## Rearview Camera Noise Optimization

Topic number	LI54.71-P-080180
Version	4
Function group	54.71 - Camera and radar-assisted assistance systems
Date	3/16/26
Validity	167 Facelift (GLE) with the following:  - Model Year 2024 and later (Option code 804, 805, or 806)  - Option Code 491 (Steel Spring Variant)  - Option Code 235 (PARKTRONIC with Active Parking Assist)
Reason for change	Adding Model Year 2026

View PRIOR to SCN Coding:

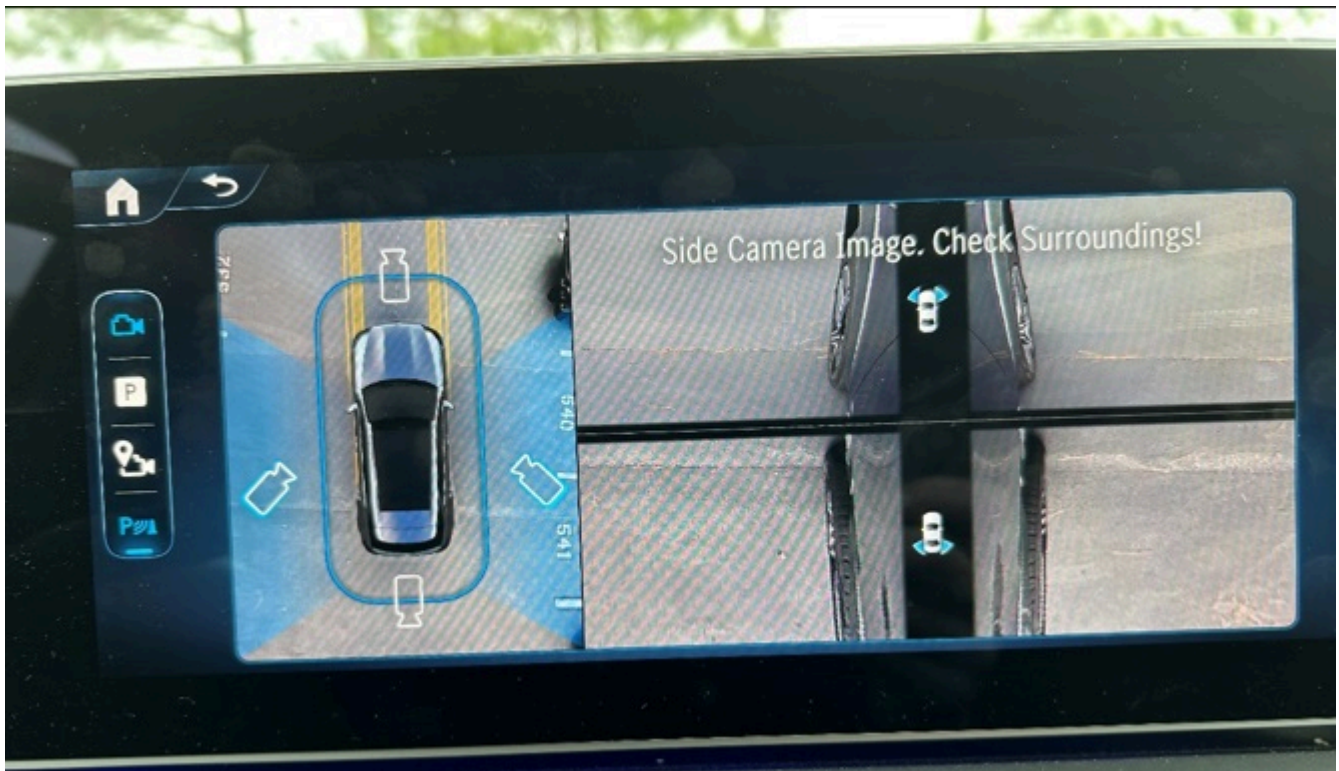
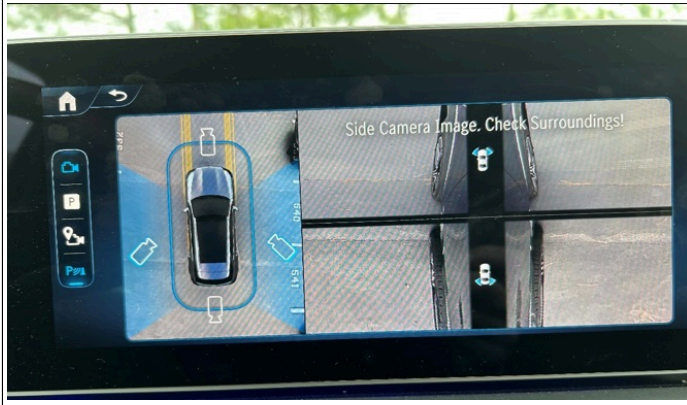
**IMPORTANT:** After both control units have been SCN coded, the "Movable 3D View" feature in the head unit will no longer be available. With this change there will be two distinct differences:

- 1) The "3D" icon when in the top down vehicle view, will no longer be present on the head unit.
- 2) The digital rendering of the vehicle with the ability to spatially move around the vehicle is no longer possible. This view is replaced with 2D static images of the left and right sides.

- Rear camera flap when calibrating after a key cycle bus sleep will stay open to 29 MPH and then close. Will re-open, when calibrating, at 9 MPH.
- The head unit screens mentioned above appear the same as "View AFTER SCN Coding" as shown in the attachment.
